**CASE NO. FP-2025-0021
ORDER OF CONDITIONAL
APPROVAL OF FINAL PLAT**

DATE: 3/17/2026
TO: City Council
FROM: Sonya Allen, Associate Planner
208-884-5533
sallen@meridiancity.org
SUBJECT: FP-2025-0021
Burnside Ridge Estates No. 2

Final plat consisting of 36 buildable lots and 11 common lots on 12.57 acres of land in the R-4 zoning district for the second phase of Burnside Ridge Estates Subdivision.

Note: This revised Phasing Plan was approved by Staff on 10/2/25

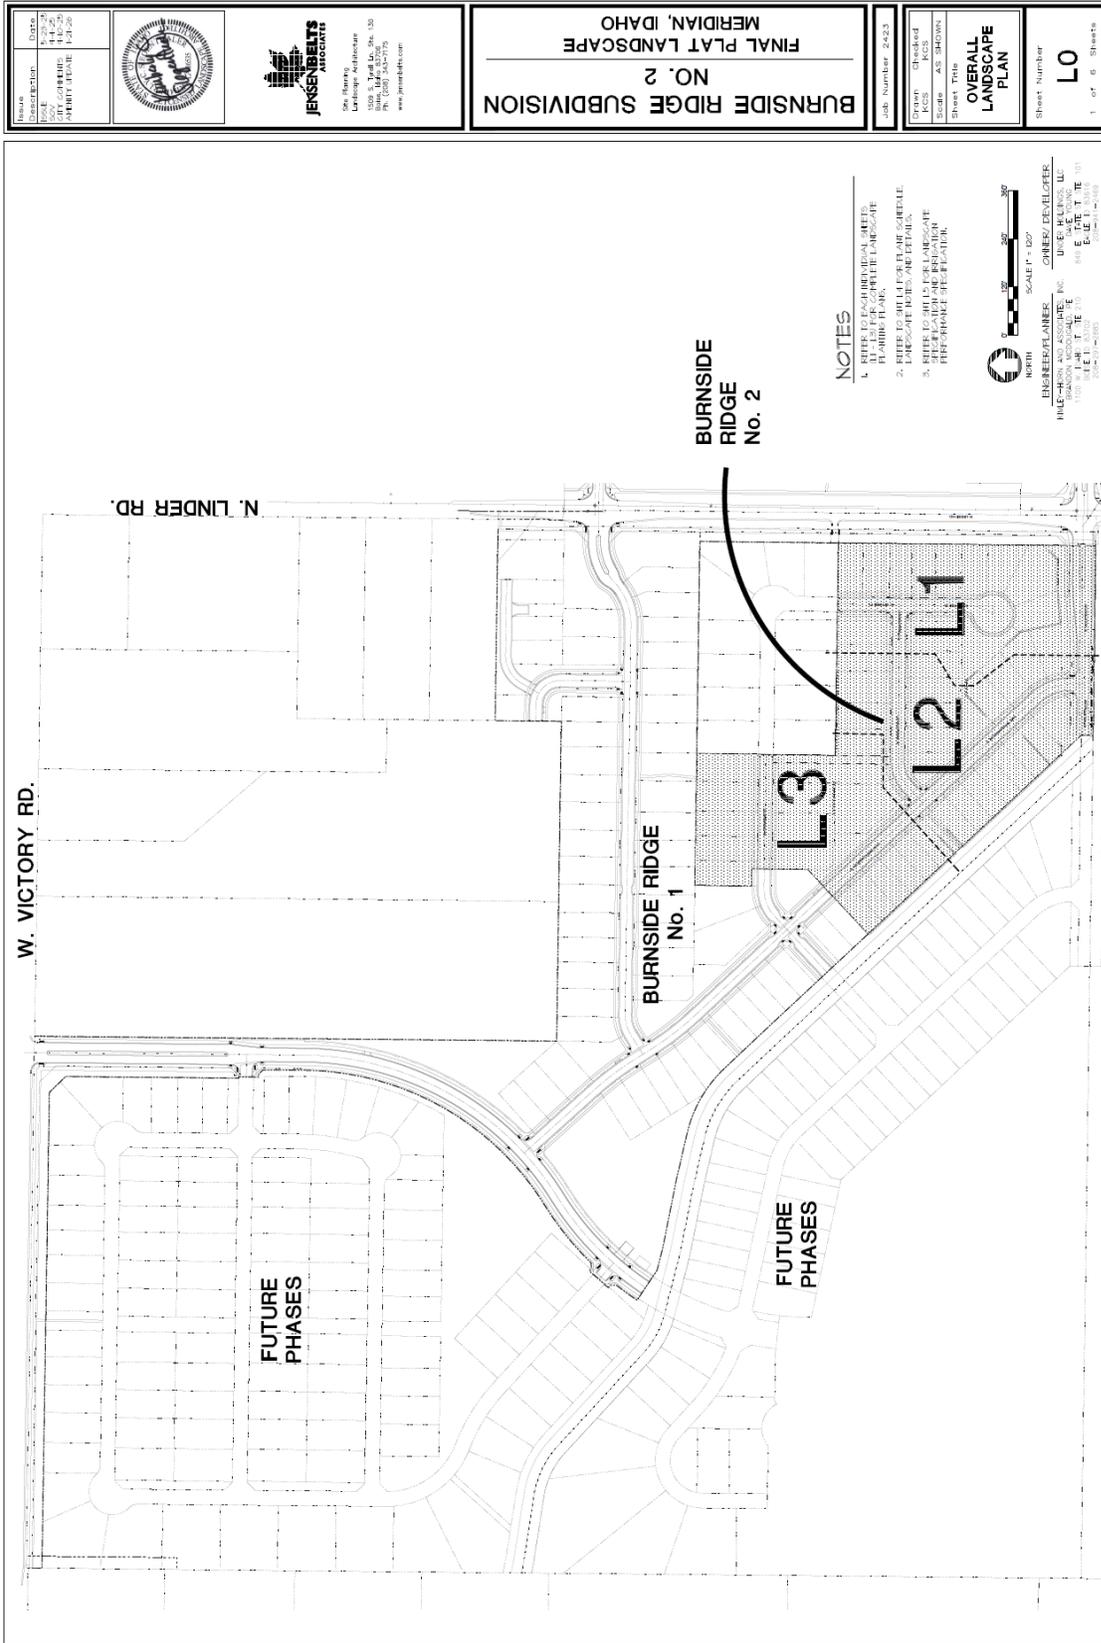
Staff has reviewed the proposed final plat for substantial compliance with the preliminary plat (H-2023-0055) as required by UDC 11-6B-3C.2. The proposed final plat includes a reconfiguration of some lots resulting in one (1) additional building lot and a greater amount of common open space (29,000 vs. 101,500 square feet) in the same area shown on the approved preliminary plat. The configuration of this phase complies with the updated phasing plan approved by Staff on 10/2/2025, included below in Section V.A.

C. Landscape Plan (dated: 1/21/26)

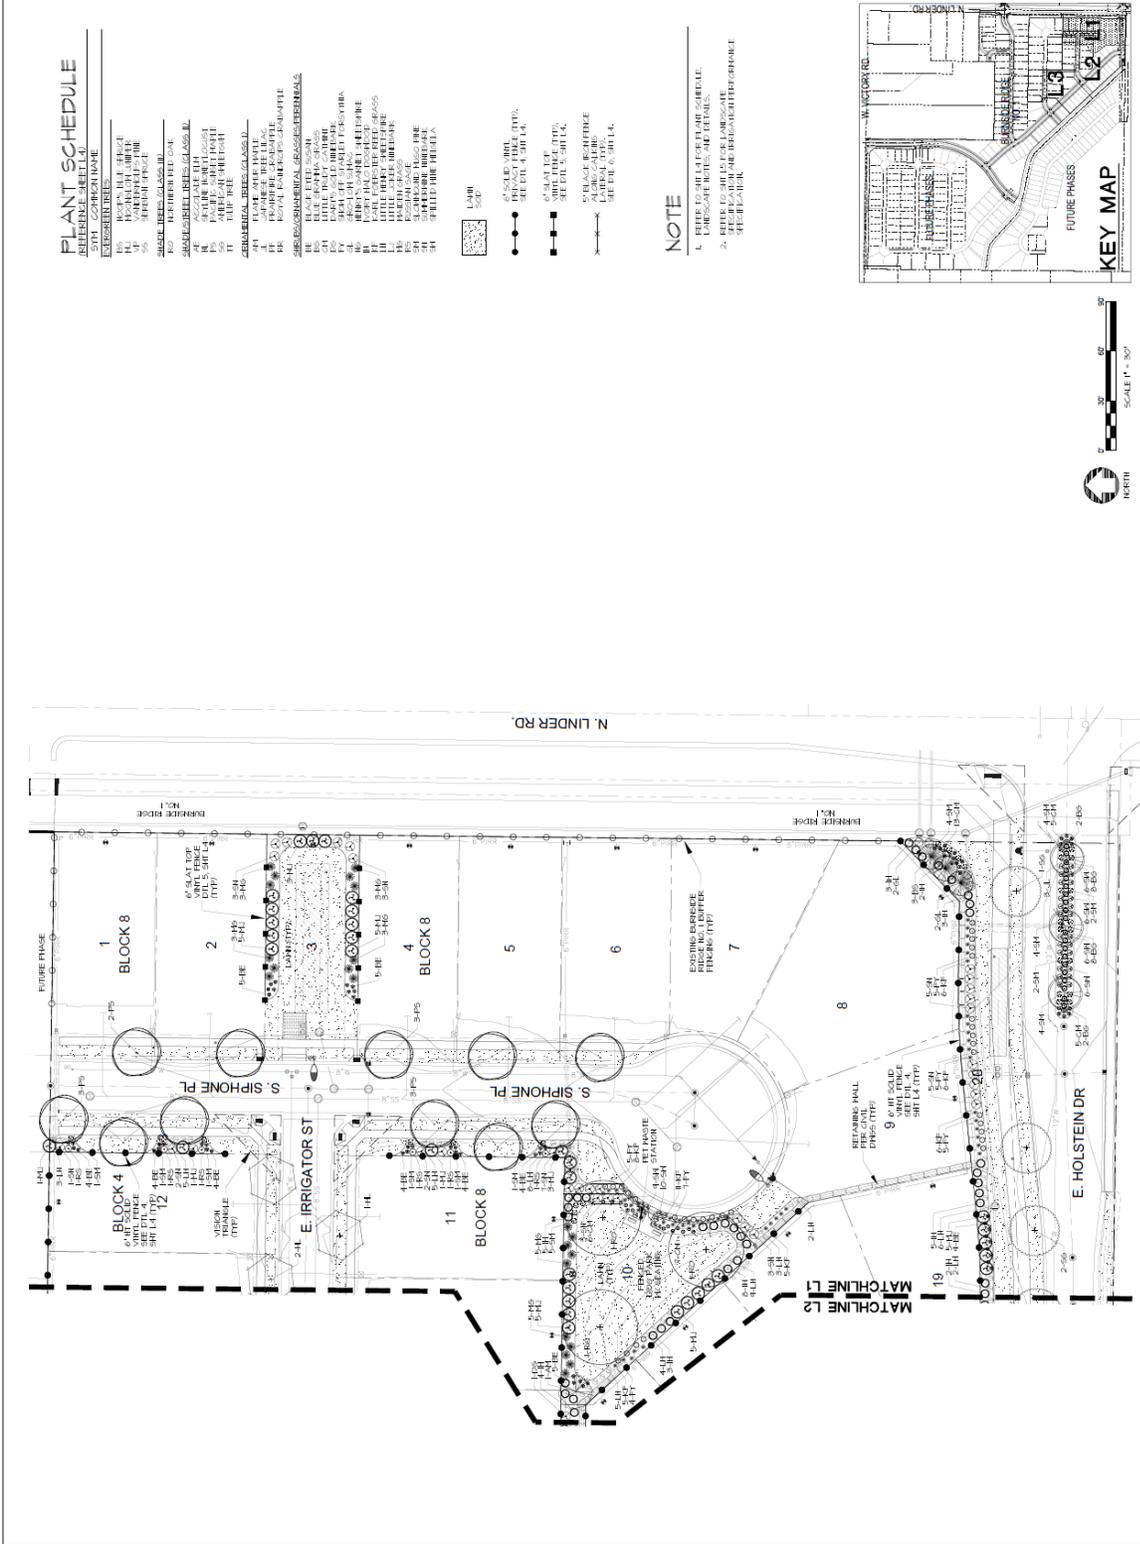
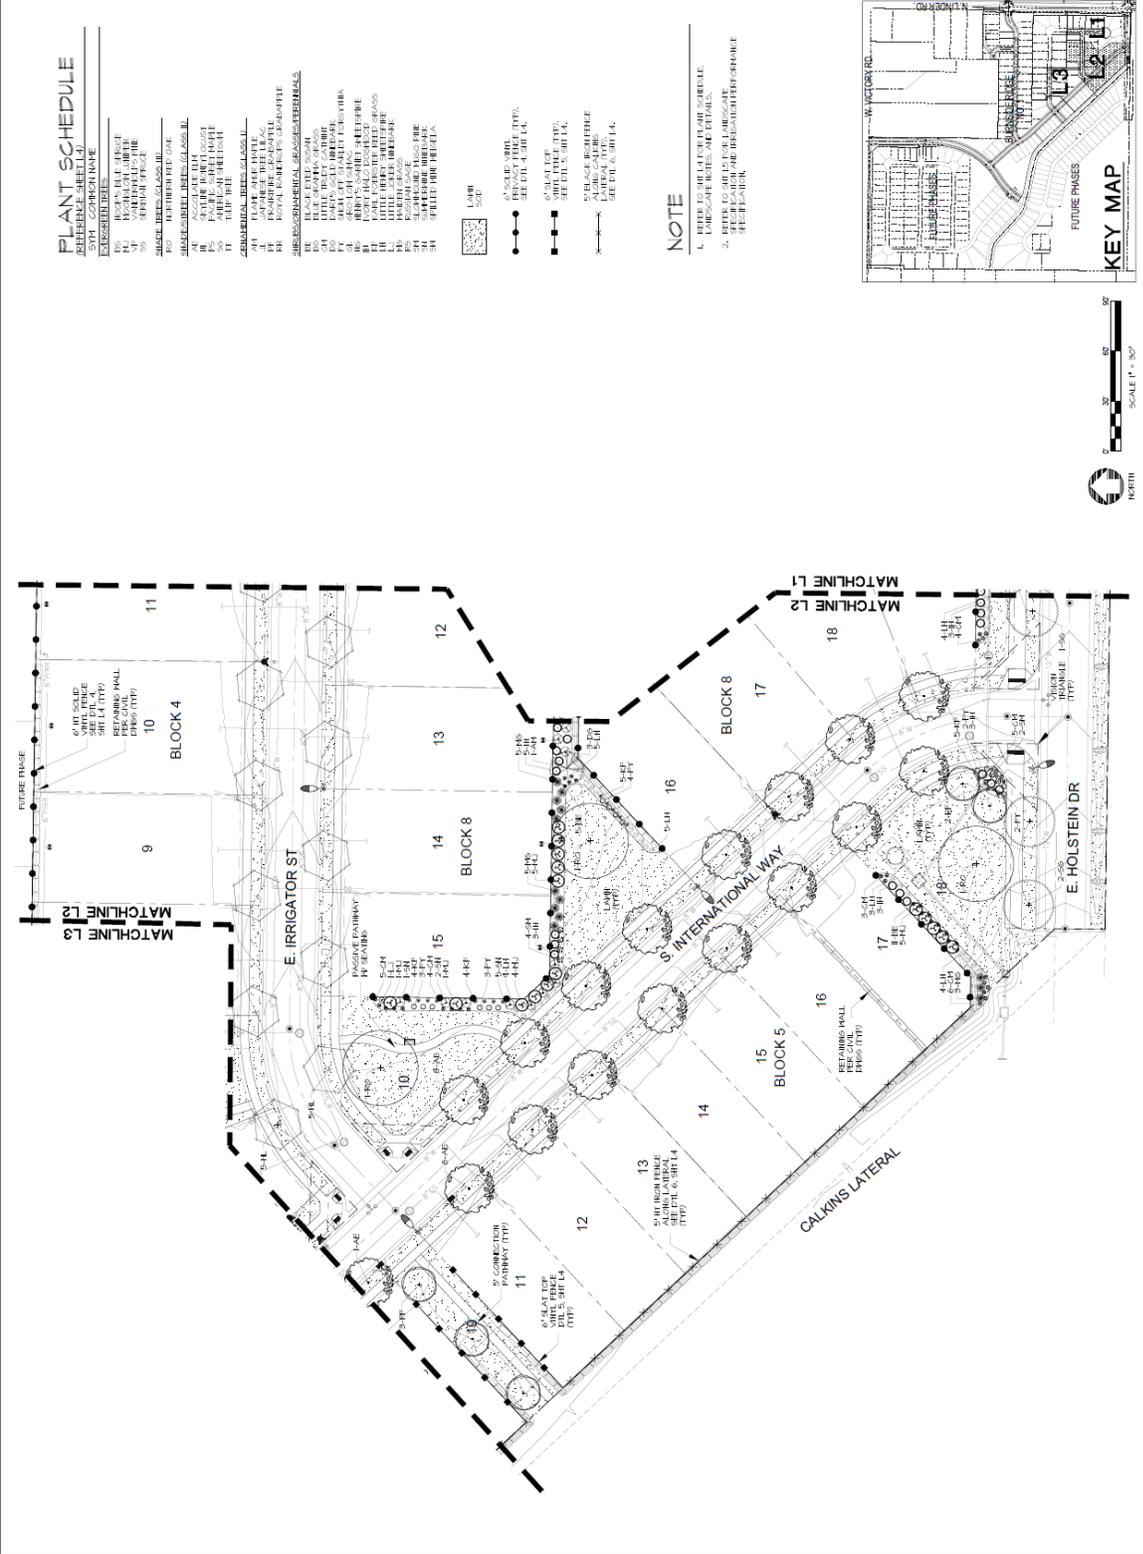
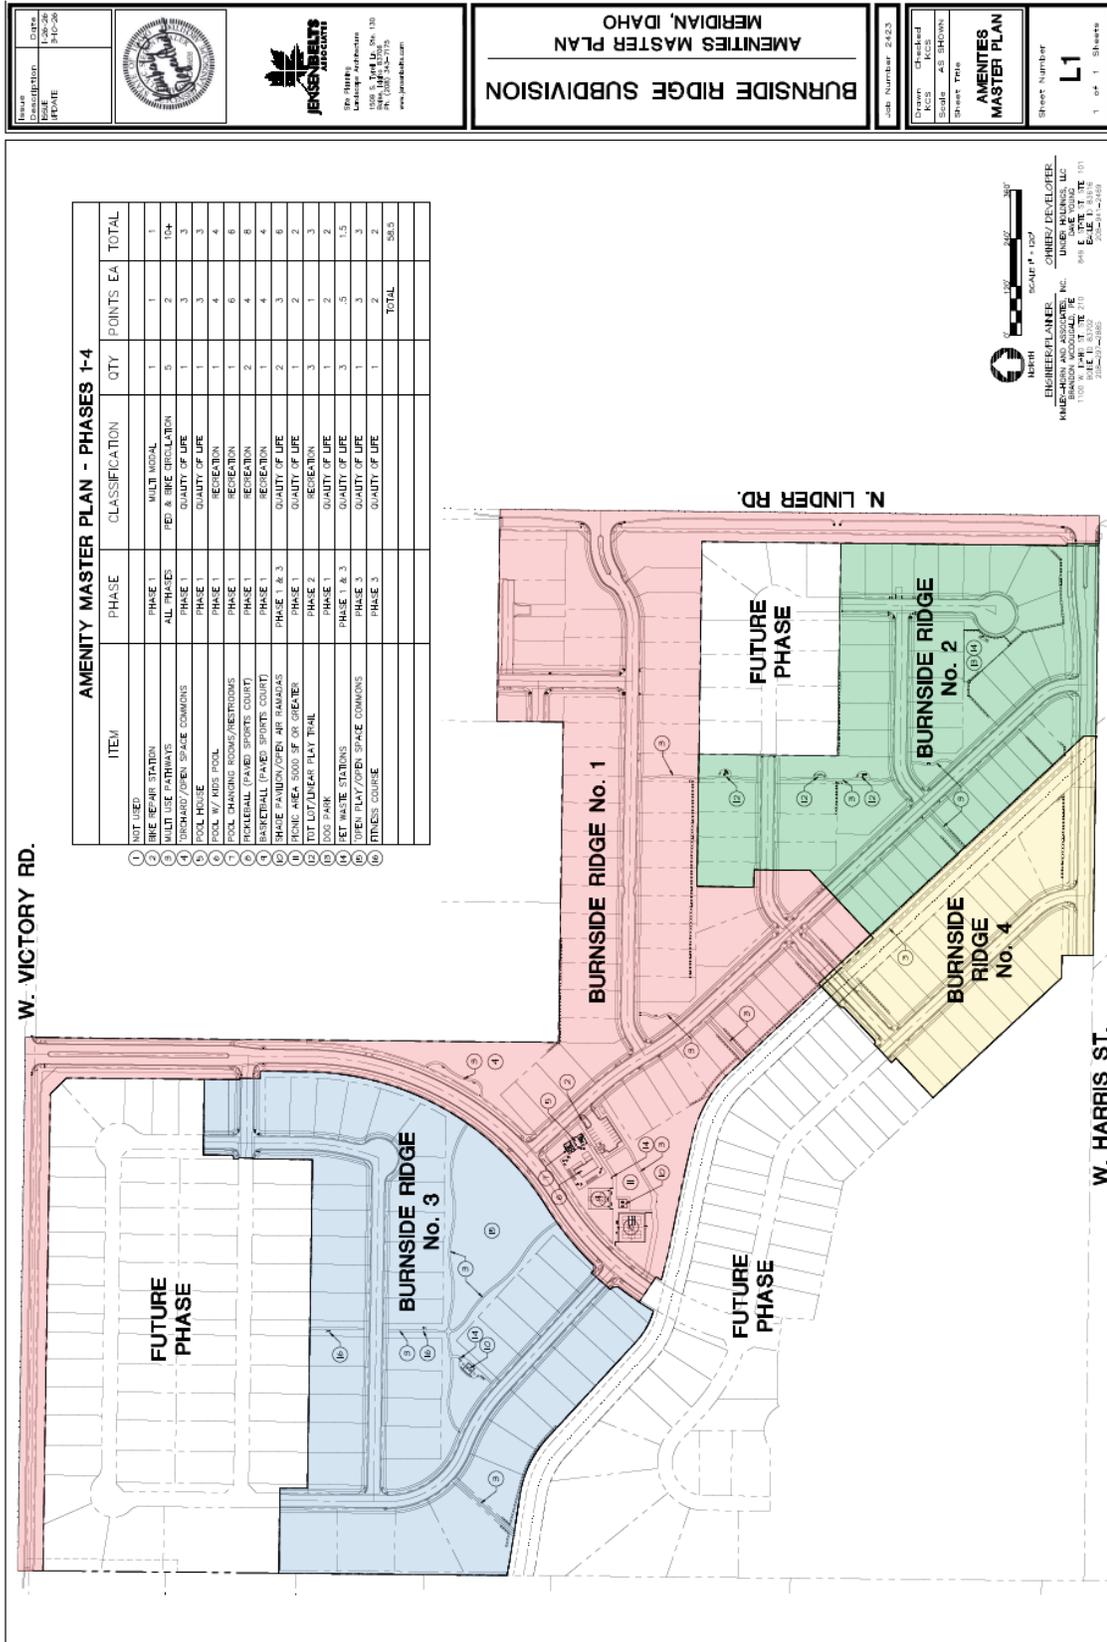
- e. Include the recorded instrument number of the City of Meridian sewer easement graphically depicted on Sheet 1.
5. The landscape plan prepared by Jensen Belts Assoc., dated 1/21/26 included in Exhibit C, shall be revised as follows:

- a. Change E. Holstein Dr. to W. Harris St. consistent with the plat.
 - b. Depict landscaping with a mix of materials along each side of all pathways, in accord with the standards listed in UDC [11-3B-12C](#); include calculations that demonstrate compliance.

- c. Include the required vs. proposed number of trees in the calculations table that demonstrates compliance with the landscape standards for pathways in UDC 11-3B-12C, street buffers in 11-3B-7C and common open space areas in 11-3G-5B.3.

- d. The street buffer along the collector street (i.e. W. Harris St.) shall include enhanced landscaping as set forth in 11-3B-7C.3f with enhanced amenities with social interaction characteristics and enhanced context with the surroundings in accord with the standards listed in UDC 11-3G-3B.3. Identify the enhancements in a call-out.

- e. Include a detail of the children's play pods proposed on Lot 5, Block 4 and Lot 25, Block 3.
6. The dog park shall include the following in accord with UDC 11-3G-4C: bags for dog waste disposal, double entrance gate, benches and fencing to enclose the area. The dog waste station shall be an in the ground fixture with waste disposal bags and trash receptacle.

D. Amenity Exhibit

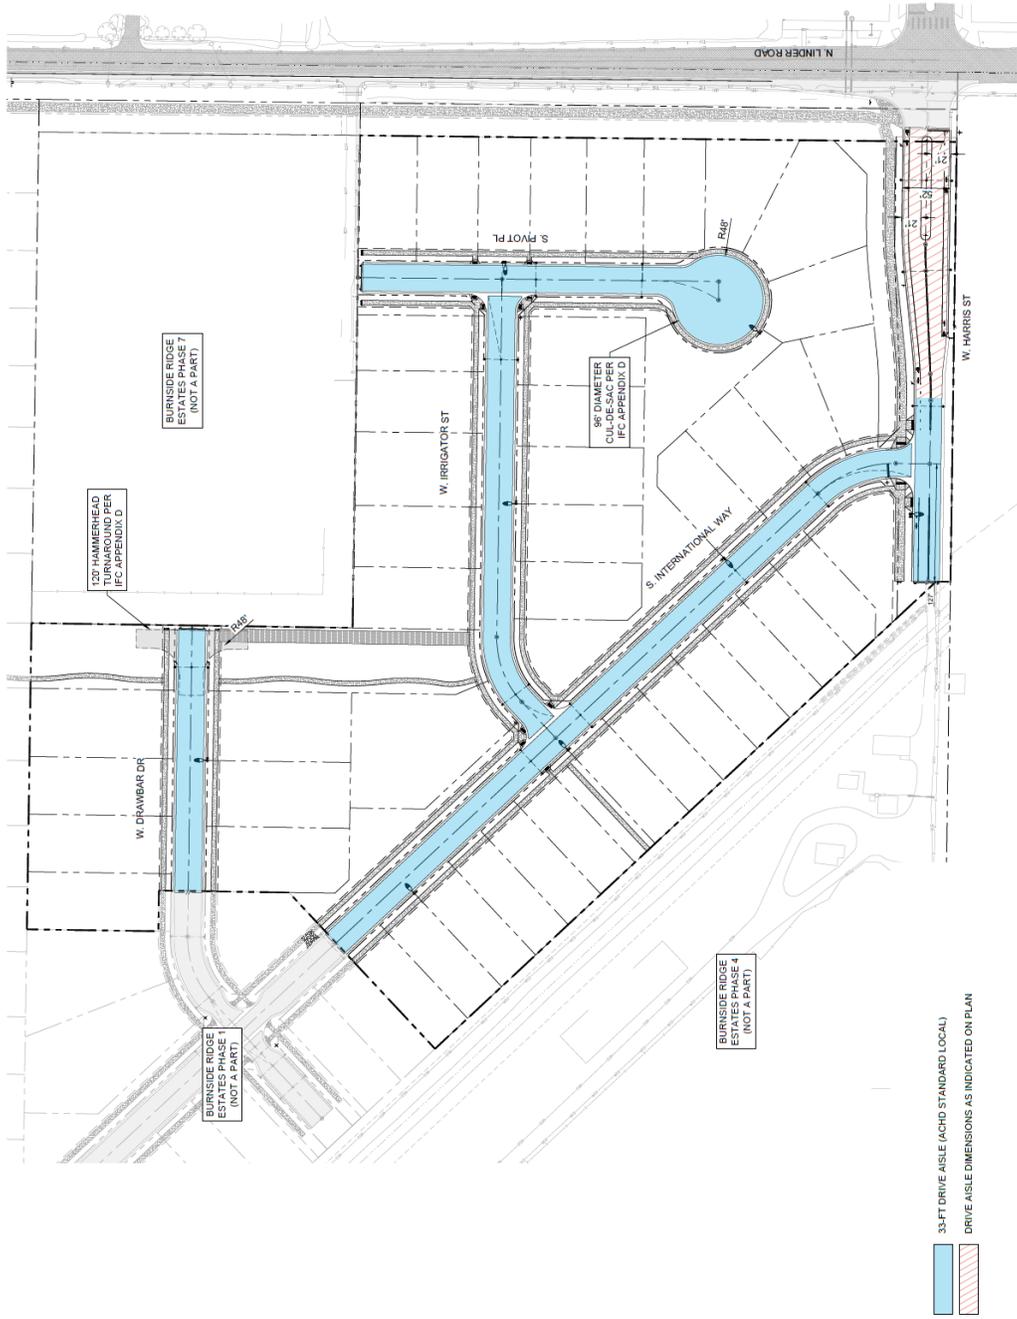
No amenities were proposed in this phase with the preliminary plat. An updated amenity plan was submitted with this application, included below in Section V.D that includes the following

amenities in this phase: a fenced dog park with pet waste stations and seating on Lot 10, Block 8; a pathway with seating on Lot 10, Block 8; three (3) play pods on Lot 25, Block 3 and Lot 5, Block 4; and internal pathways.
